16 E. Melrose Street, Chevy Chase
3513-0700

HISTORIC PRESERVATION COMMISSION

SUBJECT: Historic Area Work Permit #461023, fence replacement

EXPEDITED
MONTGOMERY COUNTY HISTORIC PRESERVATION COMMISSION
STAFF REPORT

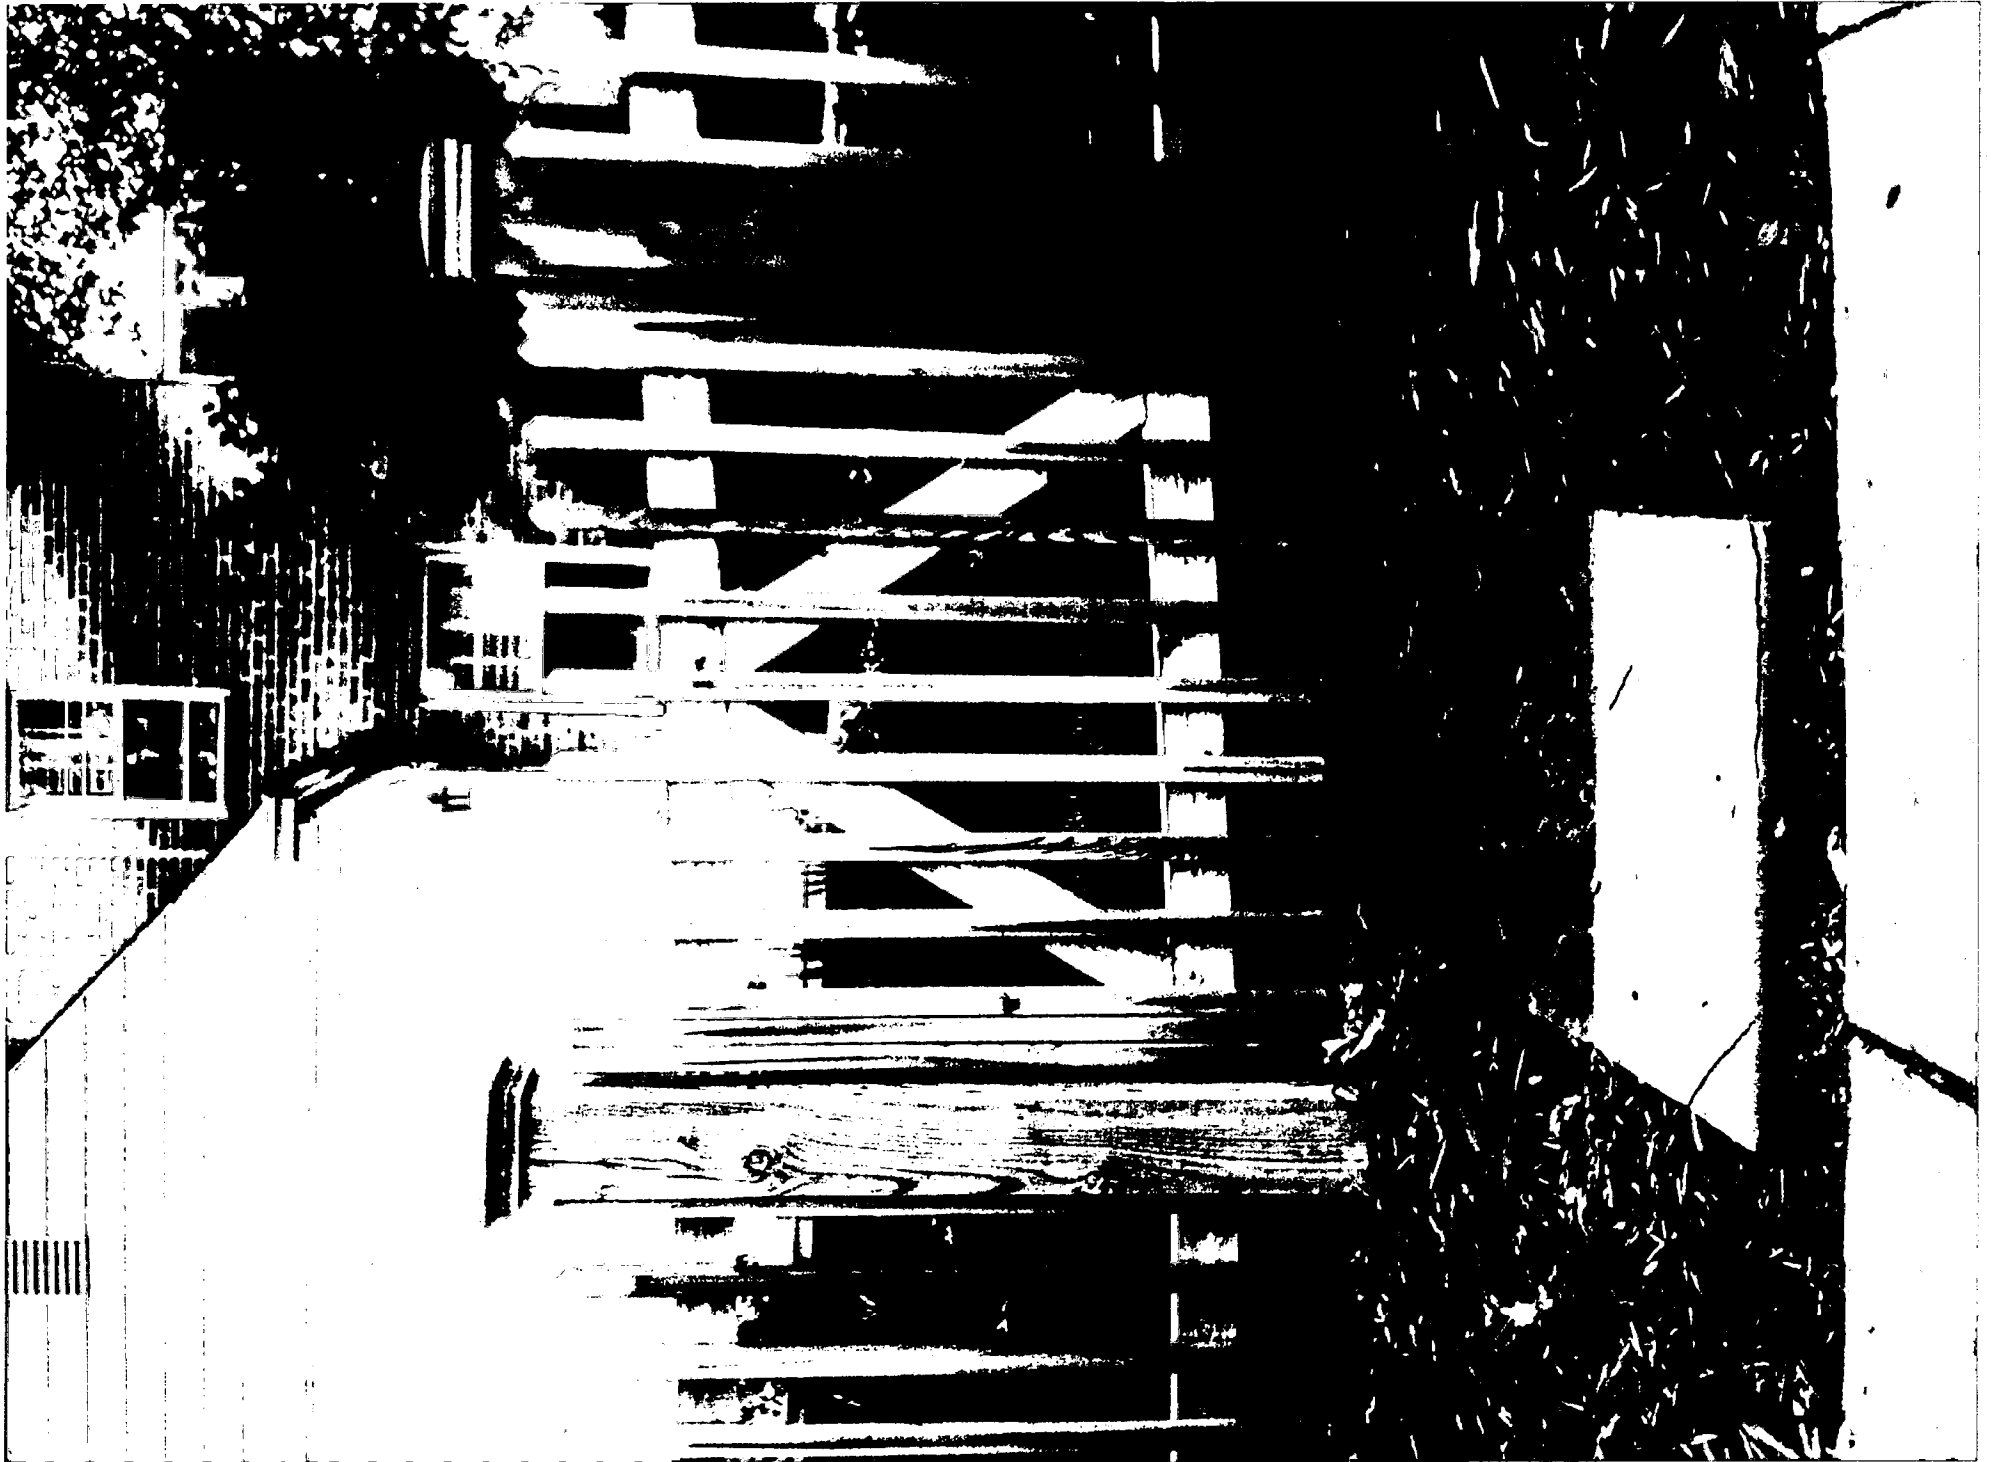
The Historic Area Work Permit for the above mentioned property was **approved** at the August 15, 2007 Historic Preservation Commission meeting. The Commission added one additional condition of approval: Detail of the proposed gates will be shown to staff prior to approval. Please e-mail me an image and the dimensions of the gate(s) you plan to use at the subject property.

Thank you for providing me with the additional information. In order to process your HAWP application I need a graphical representation of what the proposed gate(s) with dimensions will look like. This can be just a simple picture of what will be used, with the dimensions written on it. Also, have you checked in with the Chevy Chase Village arborist to discuss if a tree protection plan is needed for your project?

Thanks for sending over the image. It looks great! Could you please confirm both gates will be 4' tall. I will have your plans stamped probably sometime today. I'll call you when the plans are ready to be picked up.

I have attached a photo of the gate style we are going to use. This is the best I could find. Ours will be the same, just painted white.

In the rear, the gate will be a single, 36" wide gate. In the front, the gate will be a double, 72" wide gate.

Yes, both gates will be 4' tall. Thank you.
